Access Compliance Report

Public Rights-of-Way

(Curb Ramps)

Intersection ID: 5791	Main Street: HELLEBORE_RD	Cross Street: WOODSORREL_LN	Location: S
ADA ID: 82185064765E	Ramp Type: Perp	Initial Pass/Fail: Fail	Overall Compliance: No
		Severity Score: 22.5

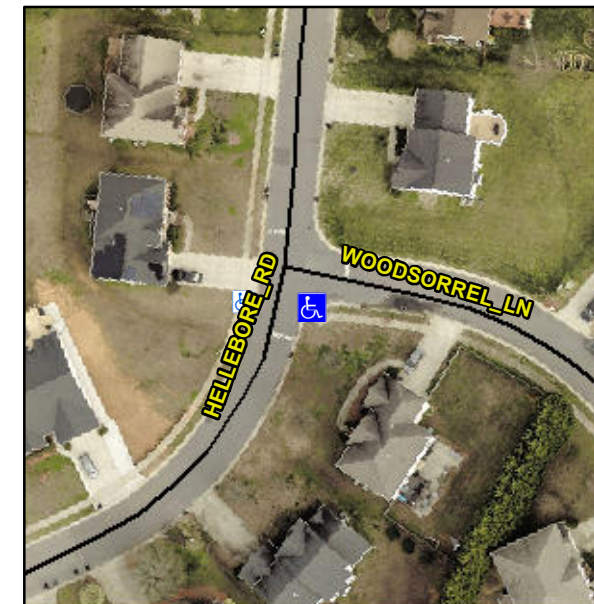
Not Found, R304.5.1, R304.2.2, R304.5.3

Compliance	Description	Data	Compliance	Description	Data
N/A	Ramp Length (in)	46.0	No	Ramp Slope (%)	8.8
No	Ramp Width (in)	46.0	No	Ramp XSlope (%)	2.1
N/A	Flare Type LT	N/A	N/A	Flare Type RT	N/A
N/A	Flare Slope LT (%)	N/A	N/A	Flare Slope RT (%)	N/A
N/A	Flare Traversable LT?	N/A	N/A	Flare Traversable RT?	N/A
N/A	Landing Length (in)	N/A	N/A	DWS Provided?	N/A
N/A	Landing Width (in)	N/A	N/A	DWS Contrast?	N/A
N/A	Landing Slope (%)	N/A	N/A	DWS Length (in)	N/A
N/A	Landing X Slope (%)	N/A	N/A	DWS Full Width?	N/A
N/A	Landing Curb? (Y/N)	N/A	N/A	DWS Offset (in)	N/A
N/A	Shared Landing?	N/A			
N/A	Gutter Ponding?	N/A	N/A	Gutter Slope (%)	N/A
N/A	Gutter Lip Ht (in)	N/A	N/A	Gutter X Slope (%)	N/A
N/A	Painted X Walk1?	No	N/A	Painted X Walk2?	N/A
	X Walk 1 Direction	To NW		X Walk 2 Direction	N/A
N/A	X Walk 1 Width (in)	N/A	N/A	X Walk 2 Width (in)	N/A
	X Walk 1 Slope (%)	0.3		X Walk 2 Slope (%)	N/A
	X Walk 1 X Slope (%)	1.6		X Walk 2 X Slope (%)	N/A

Remove & Replace Entire Ramp.
